## **TECHNICAL BULLETIN**

**505-18-15**

**MODEL AFFECTED:** 505

**SUBJECT:** CARGO HOOK ASSEMBLY ABRASION PLATES,  
INTRODUCTION OF

**Figure 2** – Cargo Hook Configuration - Post Technical Bulletin

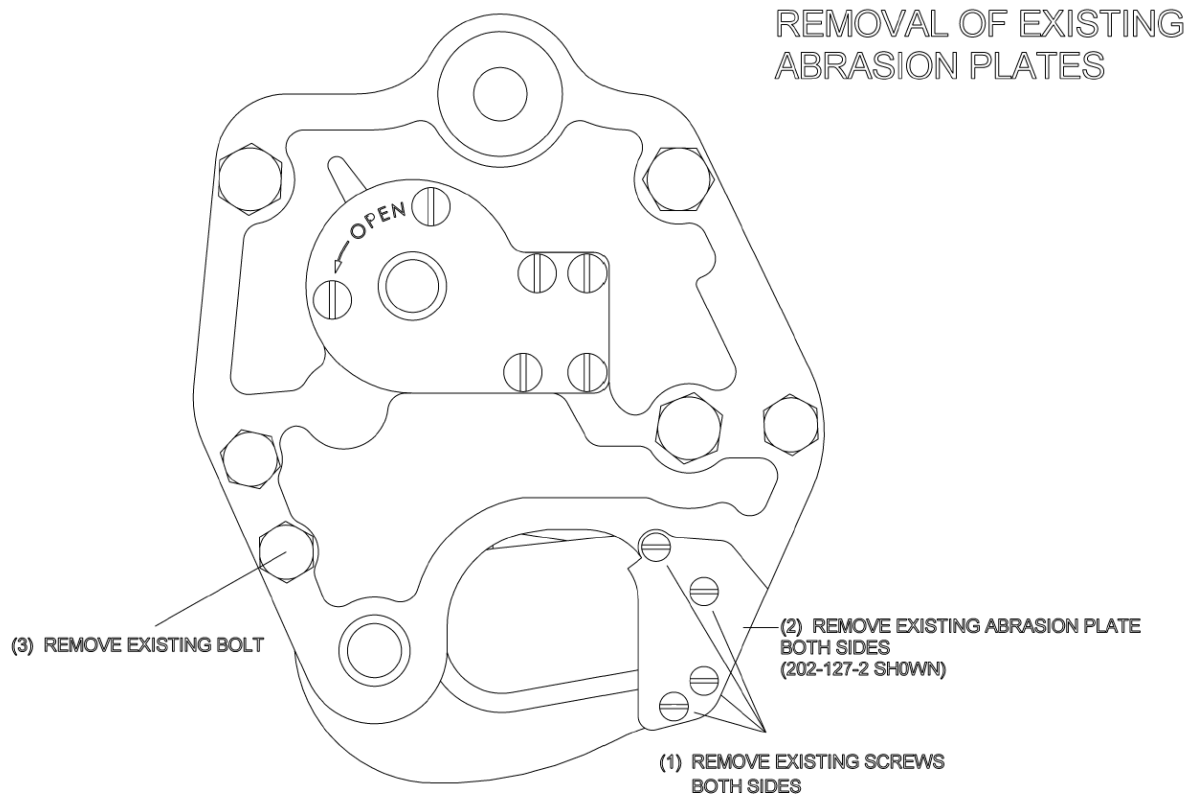
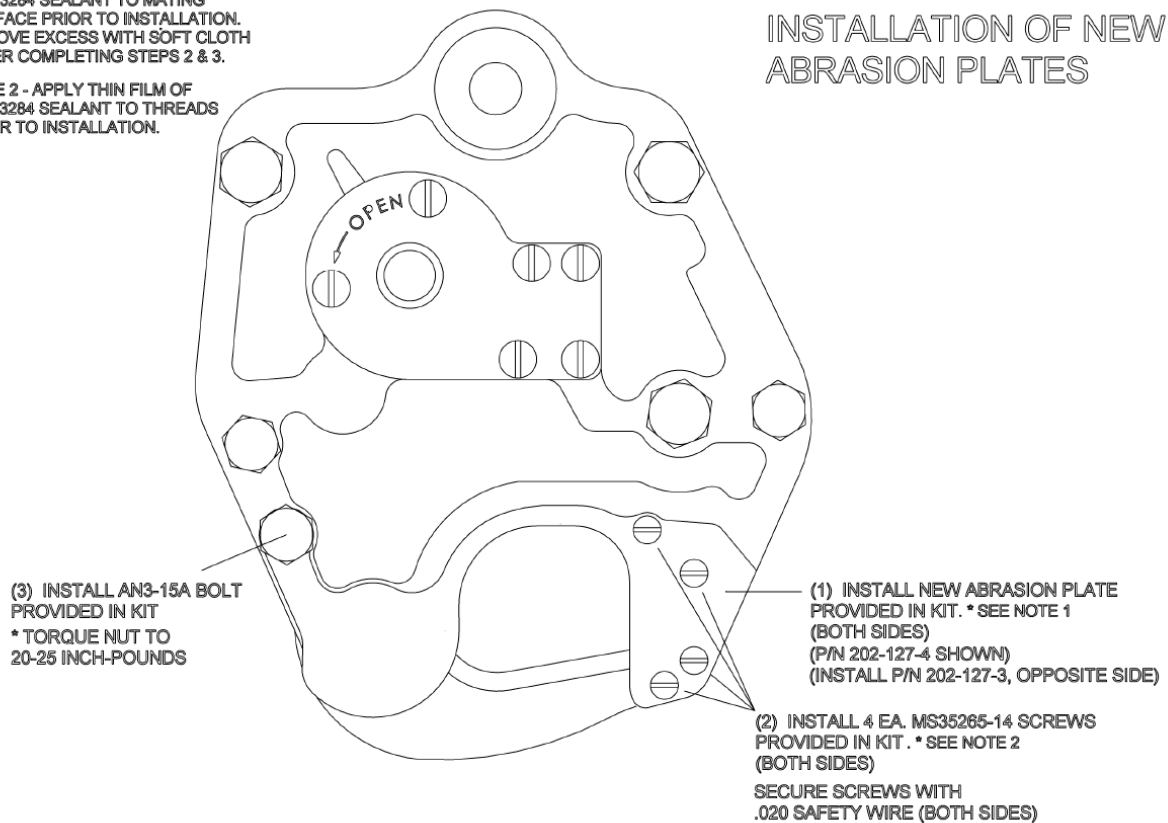
Bell has been made aware that under heavy loading, the cargo hook faces that are in contact with the load ring have shown signs of accelerated wear. Bell is introducing abrasion strips made from stainless steel to provide a hardened sacrificial wear surface that protects the cargo hook aluminum body. This Technical Bulletin introduces abrasion plate kit 202-706-127-001 to aircraft already delivered from factory fitted with a Bell cargo hook kit. Future cargo hook kit deliveries will have the intent of this bulletin accomplished.

1. Prepare the helicopter for maintenance.
2. If desired, remove the cargo hook ([DMC-505-A-25-71-01-01A-520](#)) from the helicopter to perform work on a clean table.
3. Remove existing plates and hardware (1, 2, and 3, Figure 1).
4. Ensure hook area to be reworked is clean and free of debris.
5. Install abrasion plate kit in sequence (1, 2, and 3, Figure 2).
6. Using a vibrating stylus (vibroetcher), re-identify the hook assembly as 202-100-1 (Figure 3).
7. If removed in step 2, re-install the cargo hook assembly on helicopter ([DMC-505-A-25-71-01-01A-720](#)).
8. Make an entry in the helicopter logbook and historical service records indicating compliance with this Technical Bulletin.

NOTE 1 - APPLY THIN FILM OF AMS 3284 SEALANT TO MATING SURFACE PRIOR TO INSTALLATION. REMOVE EXCESS WITH SOFT CLOTH AFTER COMPLETING STEPS 2 & 3.

NOTE 2 - APPLY THIN FILM OF AMS 3284 SEALANT TO THREADS PRIOR TO INSTALLATION.
